<h2 style="margin: 0;">Process Change Notice</h2> <h3 style="margin: 0;">PC-0007486</h3>	HIROSE ELECTRIC Co., Ltd. Koriyama factory Quality control section		
	Approval	Review	Creation

Content of change	Type	Change in lot marking method													
	Reason	For quality stability and productivity improvement													
		Before the change	After the change	The scope that will be affected.											
		Hot stamp	Laser marking	Only the marking method will be changed. The change will not affect functional performance as it is not related to design change.

Before change (Hot stamp)

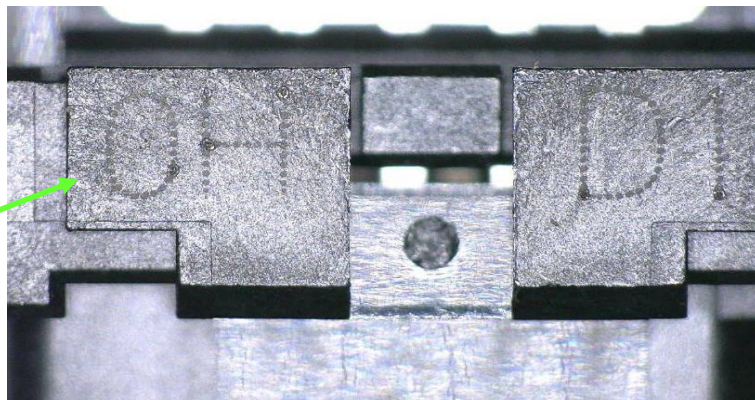
# Contents of change
